VALUE ENGINEERING REPORT

Florida Department of Transportation

SR 994/SW 200th Street/Quail Roost Drive PD&E Study

Value Engineering Study Report

Baseline Figure 1 Crash Data

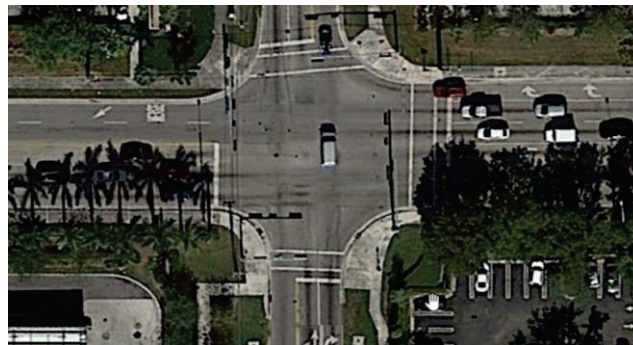
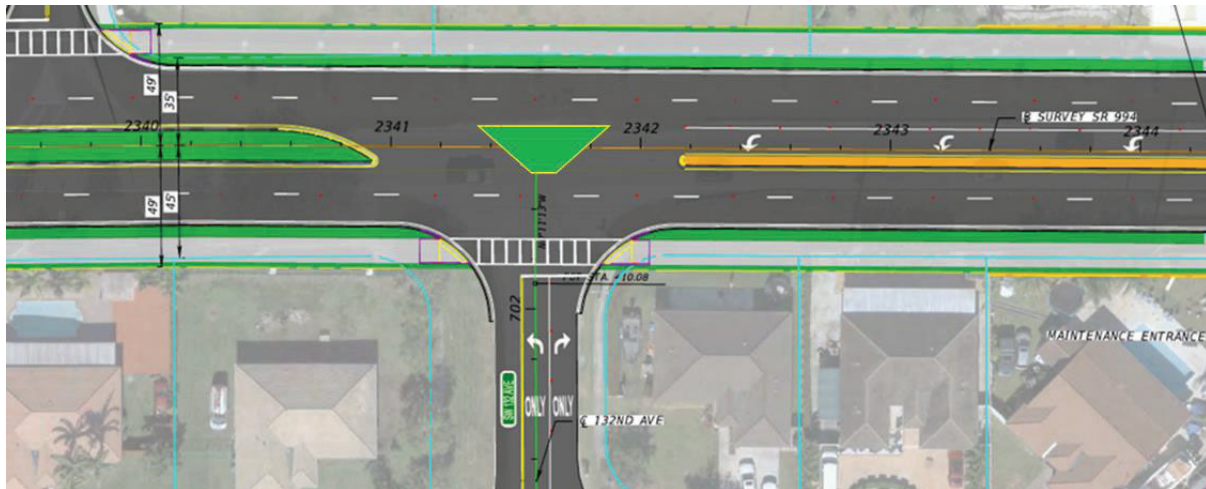
- Replacing traditional intersections with roundabouts to reduce high-speed collisions,
- Adding marked pedestrian crossings and sidewalks to prioritize pedestrian safety
- Implementing traffic calming measures like raised medians to reduce speeding
- Placing advanced warning signs and signals to provide critical information to drivers
- Installing median barriers to prevent head-on collisions or to reduce the number of conflict points

For medians at the intersections, protected left-turn lanes and signalization upgrades can prove beneficial. The selection of specific safety improvements should be based on careful analysis of road characteristics, traffic patterns, and accident data. Each improvement is tailored to improve visibility, reduce conflicts, manage speeds, and optimize traffic flow to enhance overall safety in high crash areas. Accelerating the following safety improvements can improve operations sooner.

137th: Configure intersection as shown in Recommendation Figure 1 and add adaptive signal control system with Q-detection technology. Modify the signal cabinet to adapt green light along Quail Roost. Also, add Q-loop SB to EB left turn queue to adapt green signal and improve throughput. Extend queue lanes approaching the intersection to maximum length.

134th: Signalize the intersection at 134th within existing ROW, Recommendation Figure 2 shows an example of a 78-ft mast arm placed diagonally within ROW.

132nd Ave, 133rd Ave, 133rd Ct, 130th Ave, 129th Ave: provide left turn lanes where ROW allows and provide directional bays to improve turning movements and prevent other movements, similarly as shown in Recommendation Figure 3 but one lane in each direction instead.

**VE RECOMMENDATION NO. 10:
ELIMINATE TRAIL UNDERPASS**

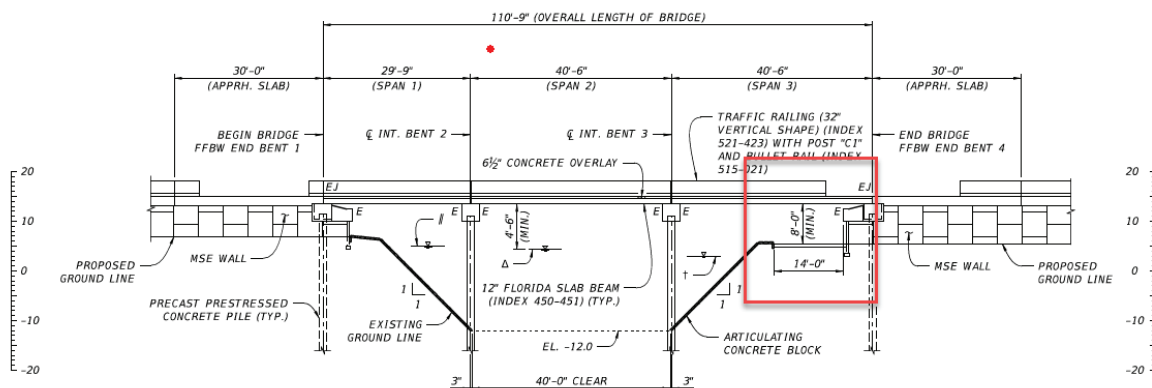
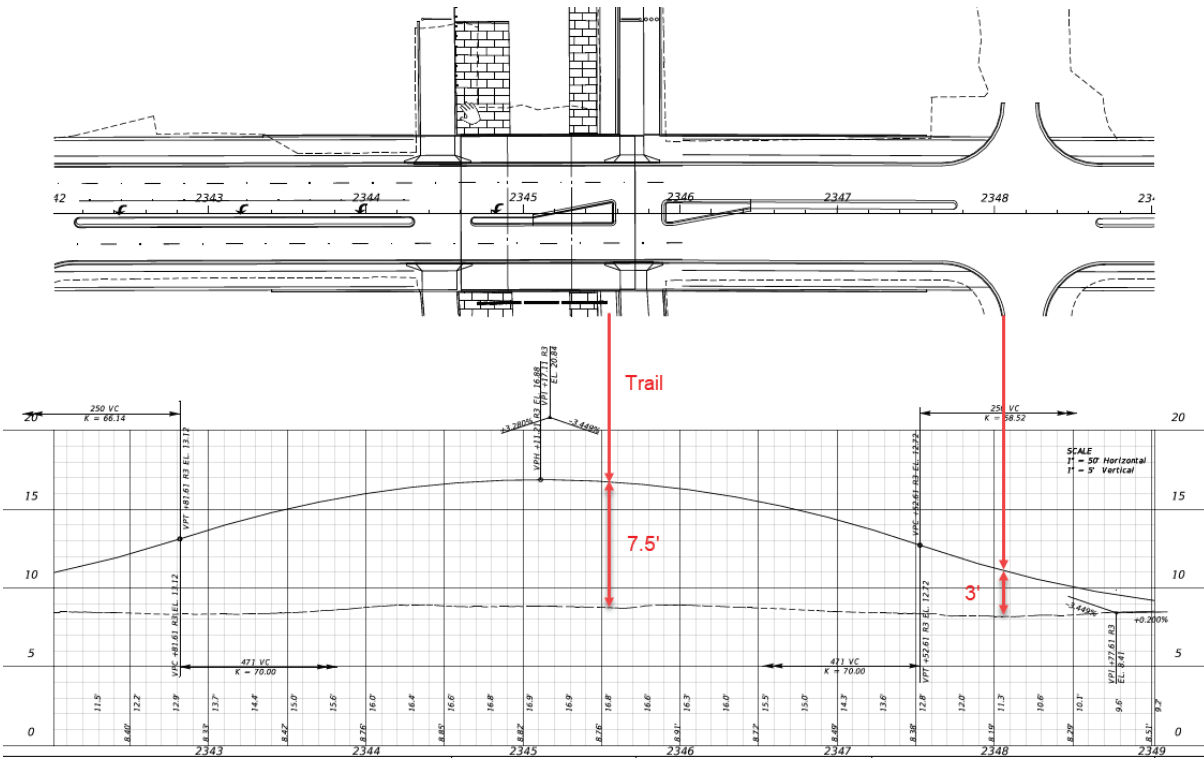
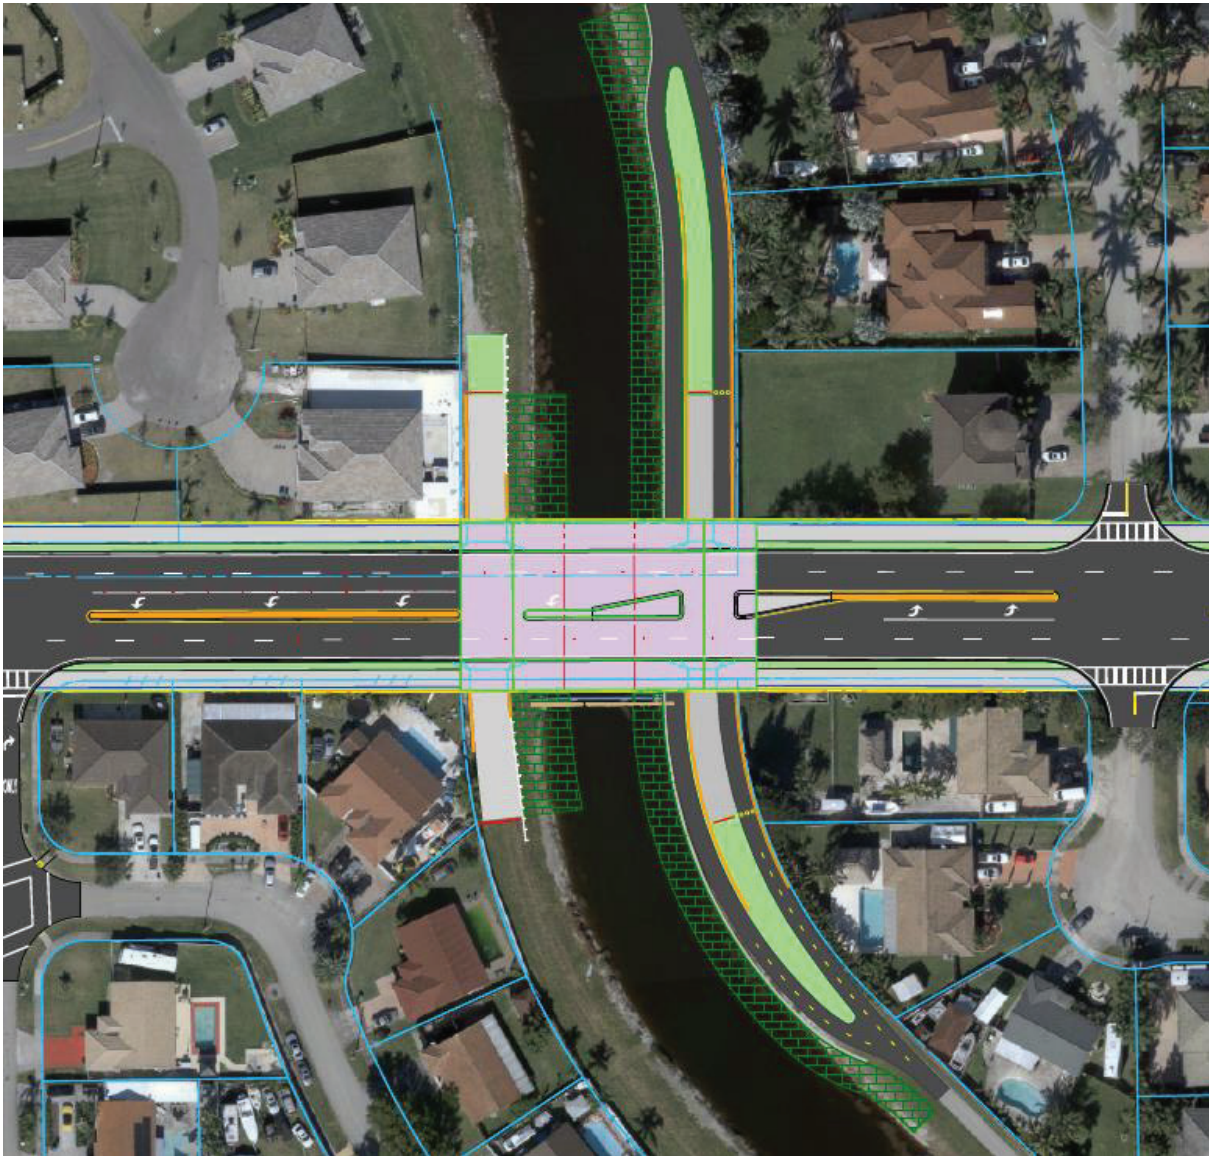
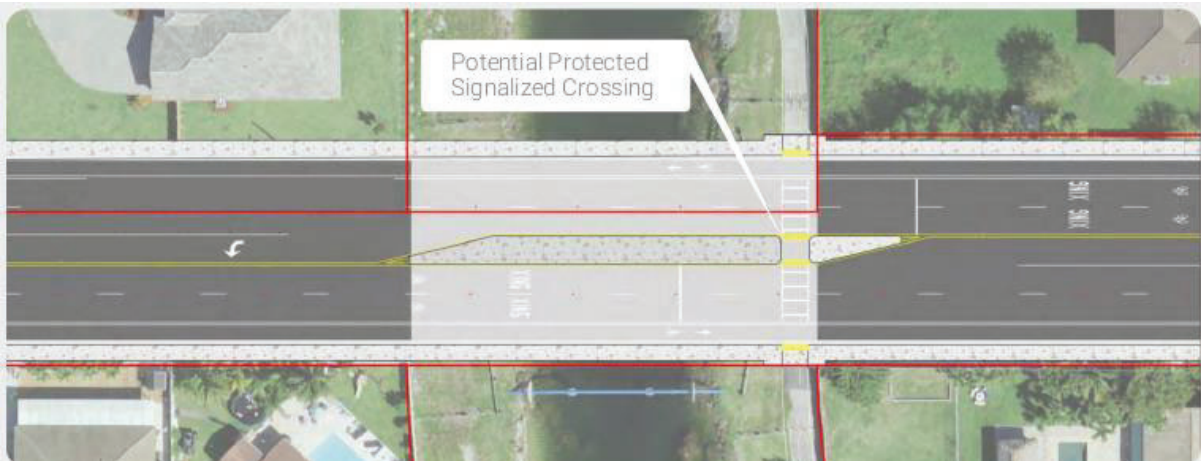
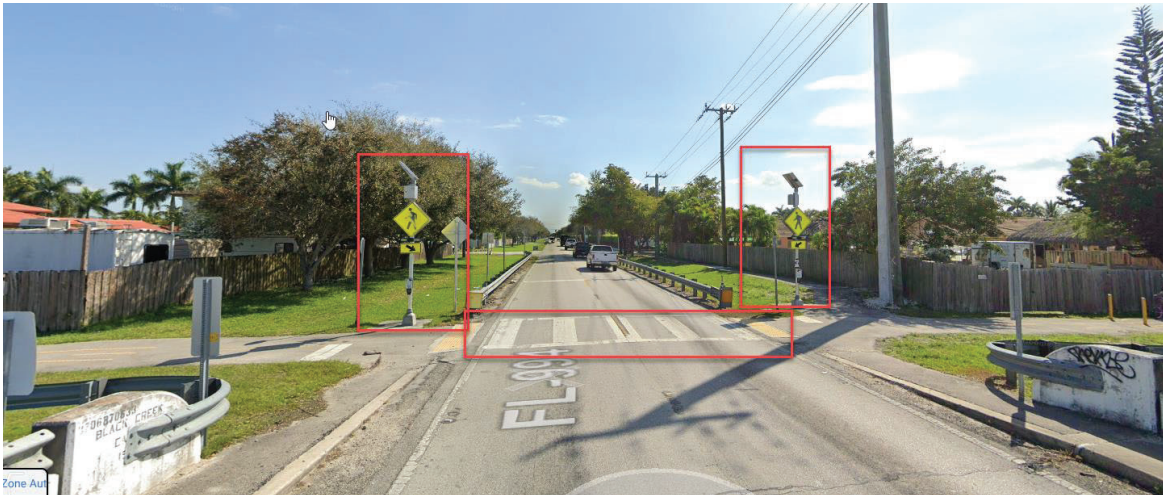
This recommendation addresses the proposed trail crossing under the bridge that crosses Black Creek Canal.

To accommodate the 8-ft minimum clearance required for the trail; the proposed ground level is approximately 8-ft higher than the existing which introduces the need for retaining walls around the bridge end bents parallel to the Black Creek Canal, and parallel to the four (4) adjacent residential properties. The proposed profile will significantly impact the profile of the side streets at the adjacent intersections.

**Idea No.
 27**

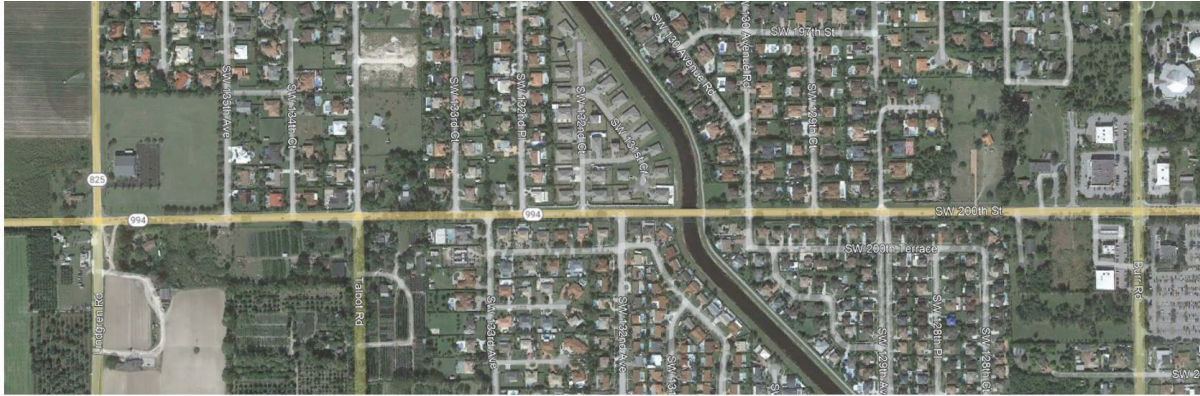
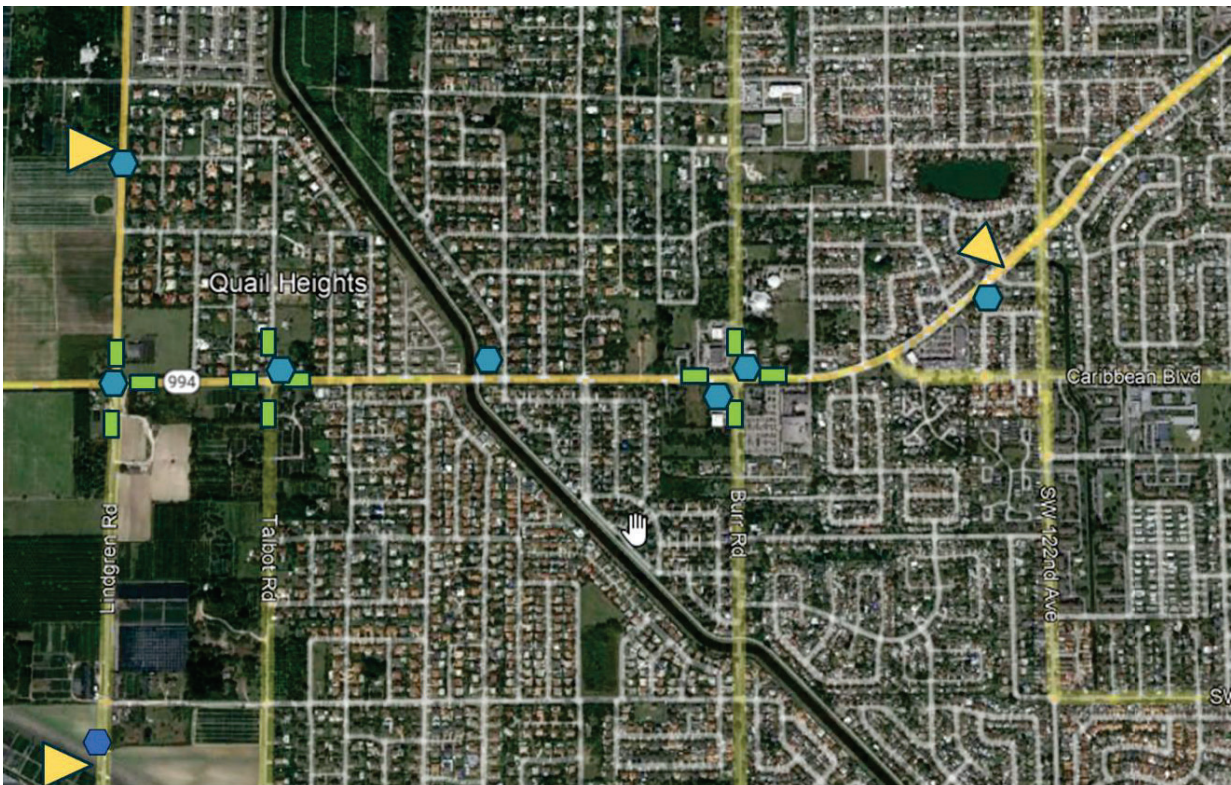
- Queue Loop Detector 
- Dynamic Message Sign (DMS) 
- Video Cameras

**VE RECOMMENDATION NO. 14:
 INSTALL ITS INFRASTRUCTURE PRIOR TO CONSTRUCTION**

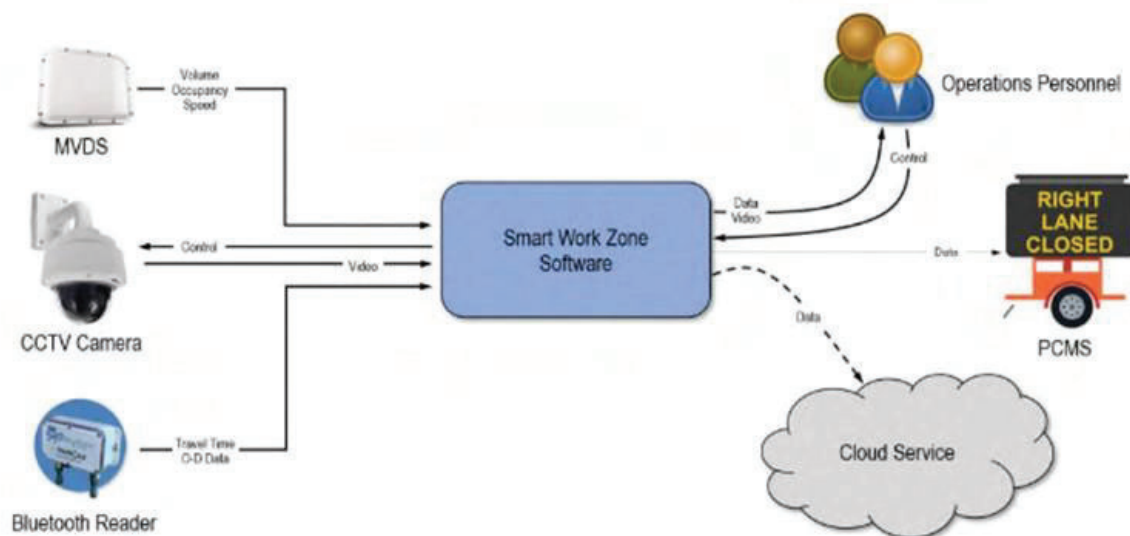
To alert the roadway users about traffic conditions within the work zone, the use of Portable Changeable Message Sign (PCMS) is proposed. The PCMS is a traffic control device capable of displaying a variety of messages to inform motorists of upcoming driving conditions.

**VE RECOMMENDATION NO. 15:
REMOVE 196TH STREET CONNECTOR**

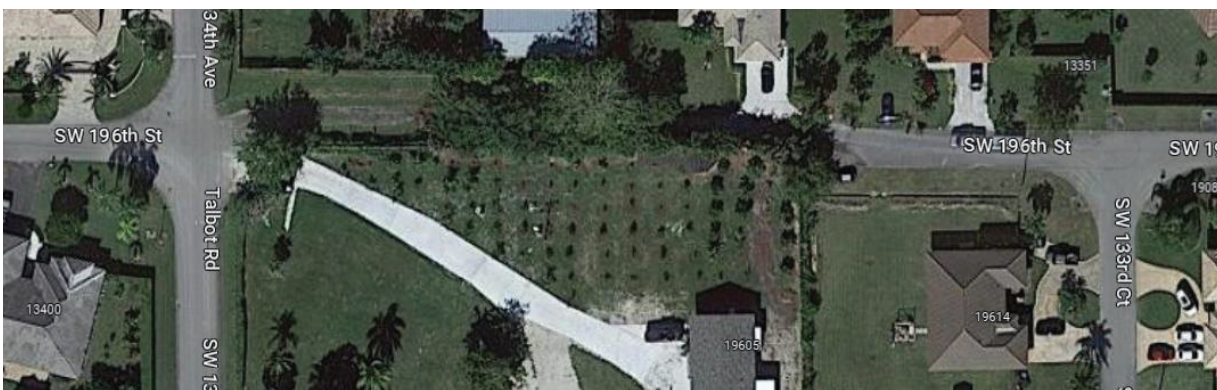
15— Remove 196th St Connector Improvements– This recommendation is to remove the proposed 196th Street improvements from the project as it is outside of the project limits.

**DESIGN VALIDATION NO. 1:
REDUCE NUMBER OF TURN LANES AT SW 127TH**

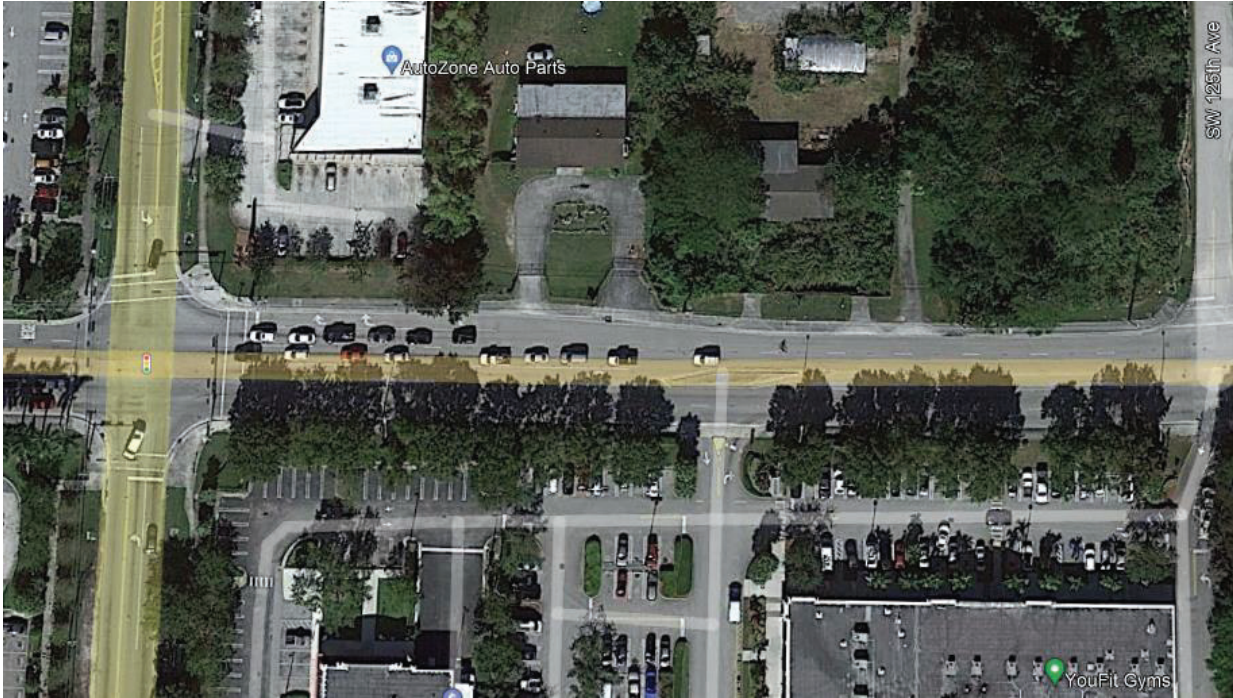
DESIGN VALIDATION NO. 1: REDUCE NUMBER OF TURN LANES AT SW 127TH		Idea No. 16	
Baseline Concept			
<p>The baseline consists of an additional left-turn lane to address the queue back-up along Quail Roost Drive and SW 127th Ave. The additional left-turn lane leads to a lane which merges and provides enough distance to reduce the amount of traffic spilled onto the intersection.</p>			
Recommendation Concept			
<p>Revisit the number of lanes at SW127th Ave.</p>			
Advantages		Disadvantages	
<ul style="list-style-type: none"> • May reduce conflict at SB SW127th lane (Merge) 		<ul style="list-style-type: none"> • Reducing amount of cars during phase • May affect through traffic due to lack of storage 	
Cost Summary		Construction	Right-of-way
Baseline Concept			
Recommendation Concept			
Cost Avoidance/ (Added Value)			
FHWA Function Benefit			
Safety	Operations	Environment	Construction
	✓		✓
